Winter Lake and China Camp Creek Projects

DSL Permit File#: 57054-RF

Responses to Comments received 1/21/15 via email from Robert Lobdell

Comments from Sharon Waterman, sent to DSL on 1/19/15

Figure 1. Location of BSDD surface and groundwater data loggers.

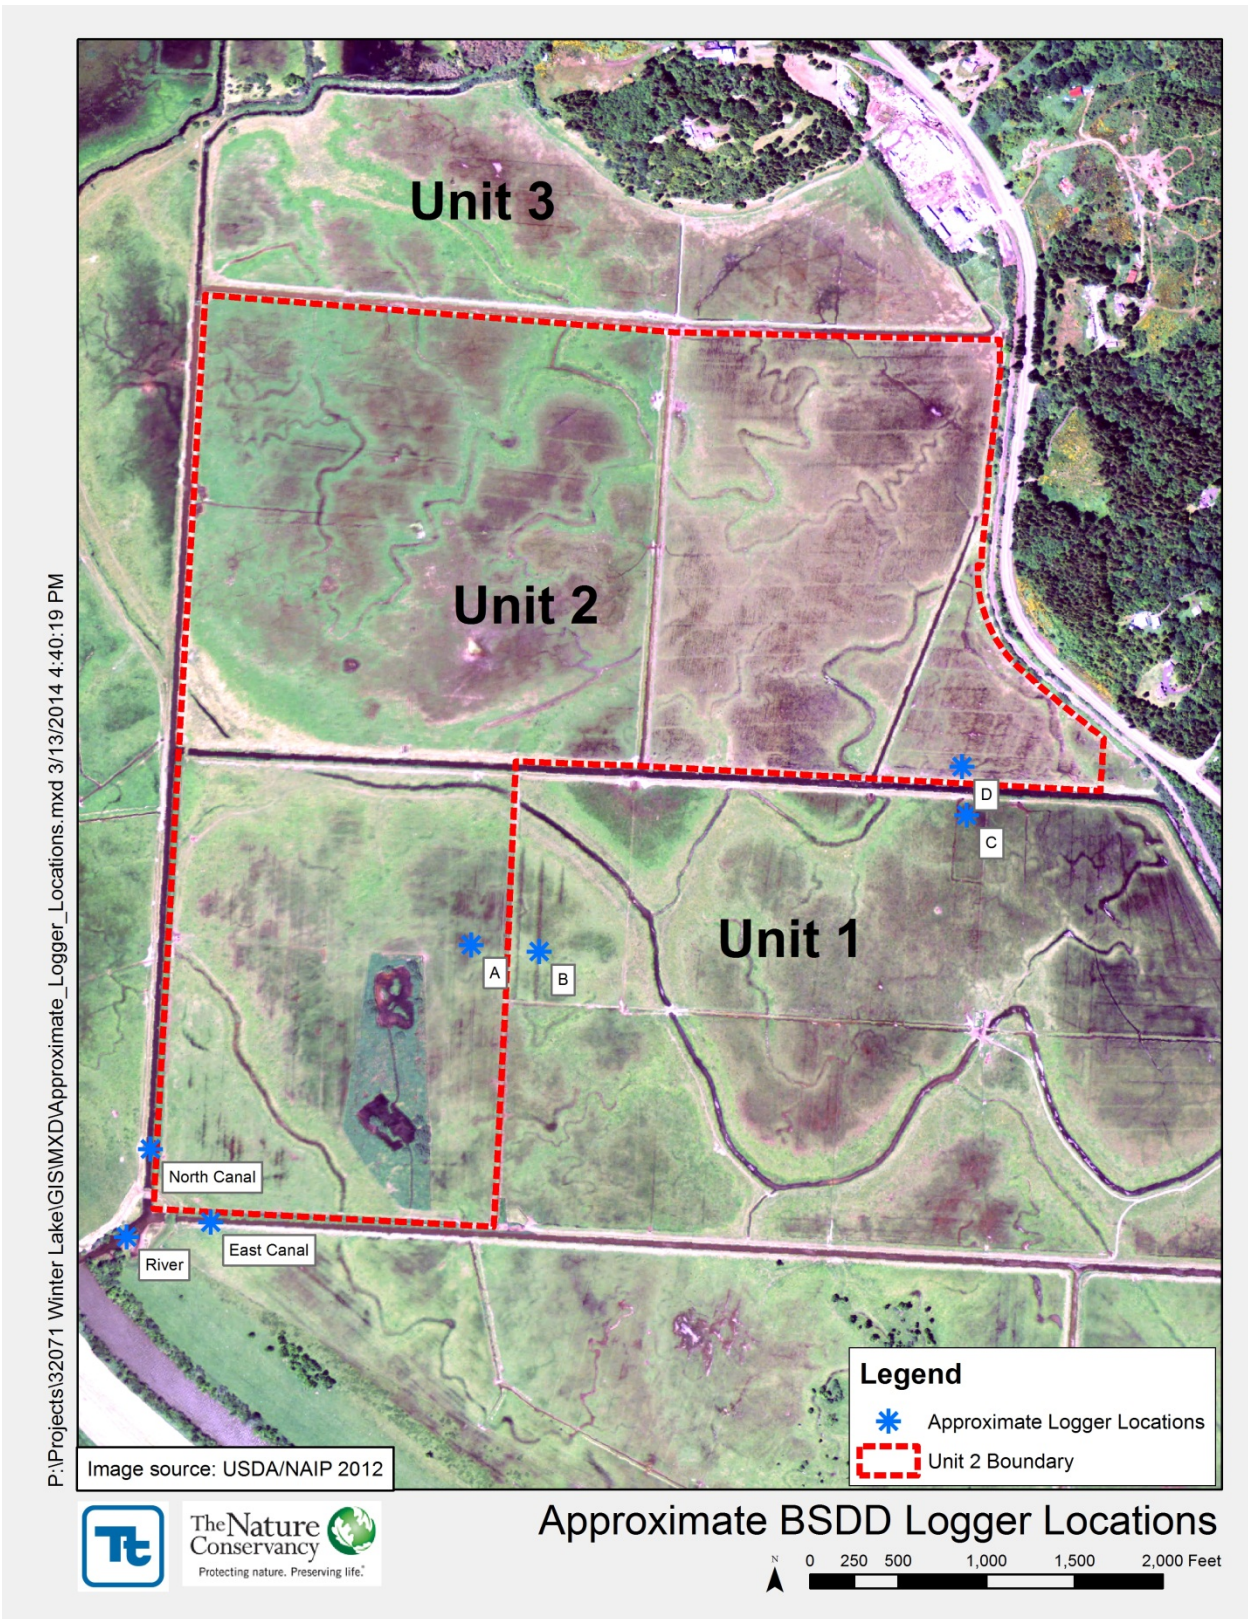
Comment #2: Effects on Adjacent Landowners Theme. *The project did not define measures that will be necessary to minimize effects on surrounding land uses and activities (industrial park and productive agriculture (EFU) lands). There appears to be no definition of the short term and long term impacts from construction and public use to surrounding land uses and activities. ---- The plans for the permit as I can see are incomplete to determine impacts to neighbors, drainage district members, etc. ----*

Response to Comment #2: Throughout the planning and design of this project, the BSDD, TNC, and ODFW have coordinated extensively with adjacent landowners to solicit comments and feedback on potential effects and other issues. Several of the landowners have replied with comments and questions that have helped to shape the design of the project. The BSDD has also requested to discuss project design with the Waterman's and has not received a response to arrange a discussion. Just recently, the BSDD has further requested input from the Waterman's regarding berm and drainage features proposed in the 90% design plans for Unit 2 (see attached letter).

The design includes specific features intended to ensure that the project does not have adverse effects on adjacent landowners, including the perimeter berms around Unit 2 and adding the new North-South canal on the east side of the CCGC property – all sides of Unit 2 will have a berm and a drainage canal that will prevent the potential for increased surface water and to facilitate the drainage of both surface and groundwater into the canals and out to the Coquille River during the twice daily low tides. The new culvert and tide gate structure will have increased capacity for spring drain down and also increase the twice daily low tide drainage capability. As the proposed new tide gates will have adjustable open/closing set points based on water elevations, the closure points can be adjusted to accommodate landowner requests in various seasons. The BSDD and ODFW have developed a draft Water Management Plan available at www.coquilleworkinglandscapes.com that outlines the tide gate set points for different seasons.

In summer and fall, when many landowners have livestock grazing, the groundwater elevations are typically at around 1 foot NAVD88, which is typically 1-4 feet below field level (see Figure 1 and 2, below, reproduced from previous design memoranda, Tetra Tech 2014a and 2014b), as measured in piezometers installed by the BSDD in March 2011; the data set evaluated by Tetra Tech was from November 2011 through November 2013. The drainage canals serve to lower the groundwater table and the berms serve to prevent surface water flow from one site to another at water surface elevations less than the winter inundation level.

Figure 3. Model predicted inundated areas within the canals and Unit 2 for the highest simulated tide and the proposed project.

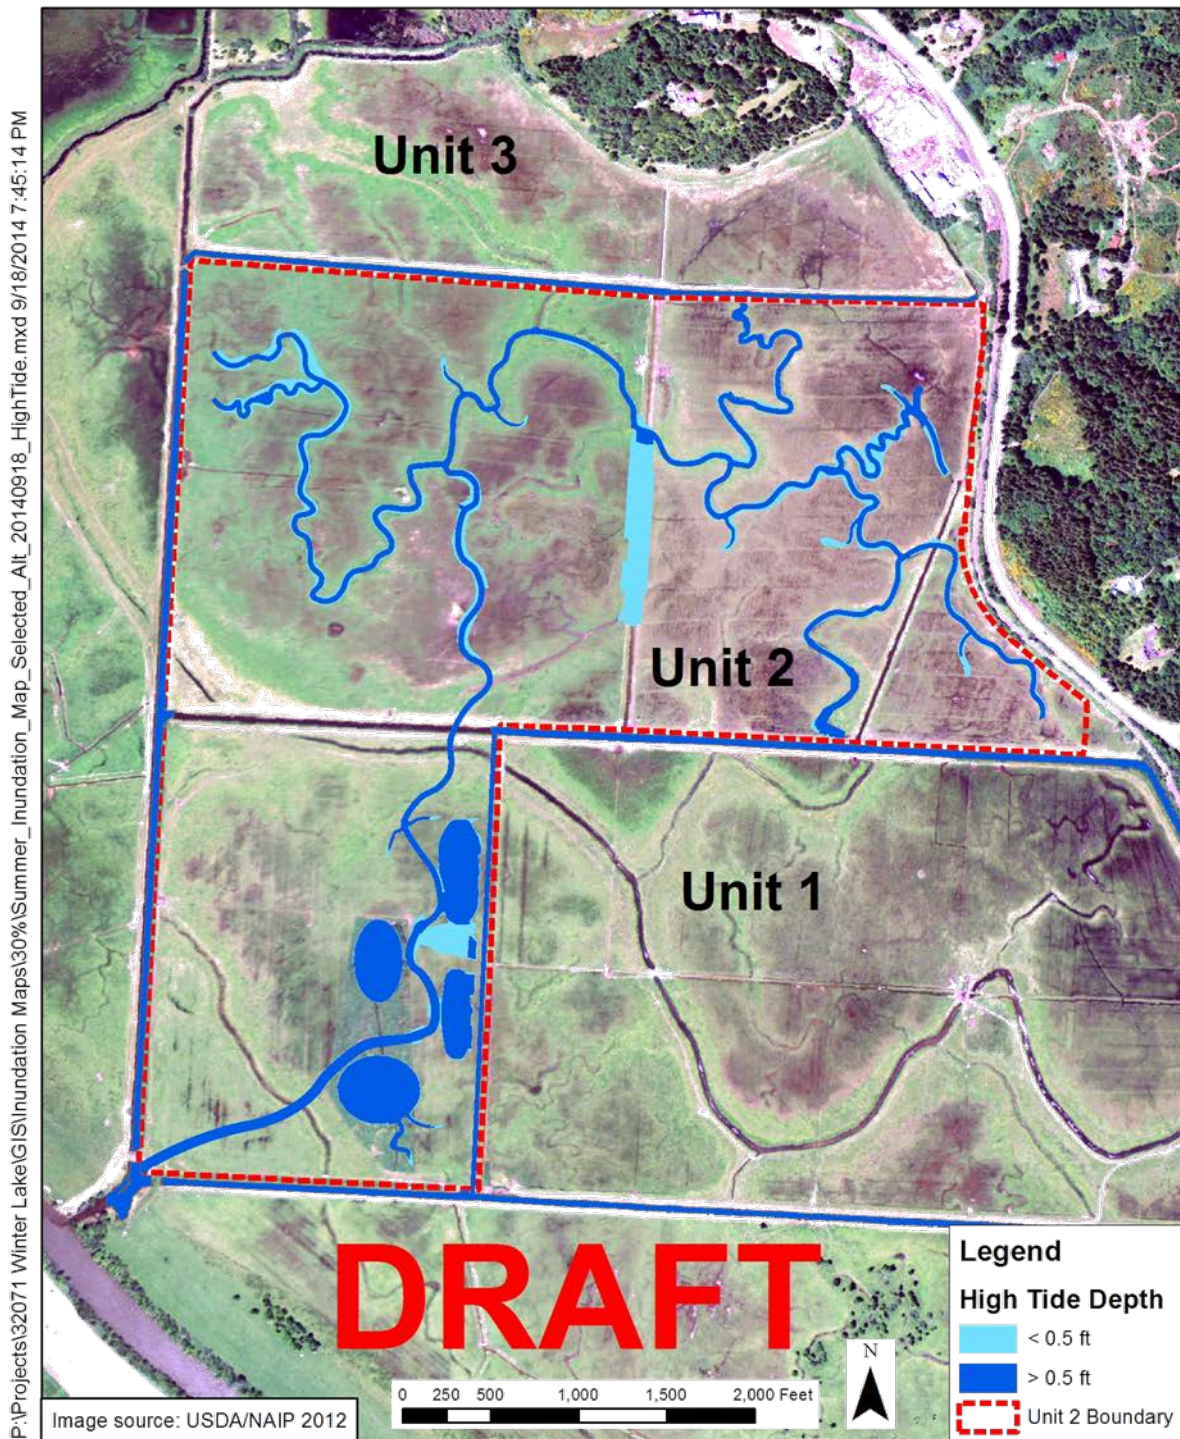
Comment #9, Water Quality Theme. *One must consider the water quality issues of this project. Depending on the Water Management Plan, should water be placed in the shallow ditches over the wetland, will it come out warmer and contribute to the temperature increases in the Coquille River during the summer months. When one considers the wetland has four 8'x10' tide gates to flush water in and out of the wetland, I would doubt if the amount will stay in the small stream system this project is creating. During the summer hot weather, it is common sense that the water returning will be warmer since the land temperature is warmer as well as the air temperatures. Currently, under this drainage system, the cooler ground water drains into the Coquille River during the summer months. This project will add warmer waters from the wetland into the Coquille River creating increase in Coquille River temperature.*

Response to Comment #9: The primary habitat channel system and connections to existing remnant swales on the ODFW property will not be a small and shallow system. The channel at the culvert/tide gate end (downstream end) will be at elevation -3 feet and have a 50-foot bottom width. The channel decreases in width to about a 25-foot bottom width all the way at the upstream end of the channel and a bottom elevation of 0 feet NAVD88. This means that the channel will have at least 3 feet of water depth at the lower end at all time (even during low tides) and at least 1 foot of water at the upstream end during low tides. During high tides, the water depths will be on the order of 3-6 feet. The water will also generally be flowing in or out, with only a short amount of time (approximately 30 minutes at the upper NE corner of the ODFW site) at the turn of the tides where there is little to no flow. This will substantially reduce any potential for solar heating of the water as it will flow in and out regularly, and also capture stream flow at the upstream end of the channel. Further, ODFW and TNC will be planting over 100,000 trees and shrubs for shading that will result in much less potential for solar heating.

Hydraulic modeling of the propose project indicates that during summer/fall low flows, the four 8'x10' culverts and proposed channel dimensions are needed to ensure that tides flow all the way up to the upstream end of the channel during high tide, and to allow drainage down from the upstream end on each tidal cycle. This is a primary feature to minimize mosquito populations and also allow fish to access the entire system and not be stranded. As the tide gates close at a predetermined set point (such as 3.5 feet or 2.5 feet NAVD88), the upper end of the high tides are muted and the entire flow volume stays within the channel system (see Figures 3 and 4 below, reproduced from Tetra Tech 2014a).
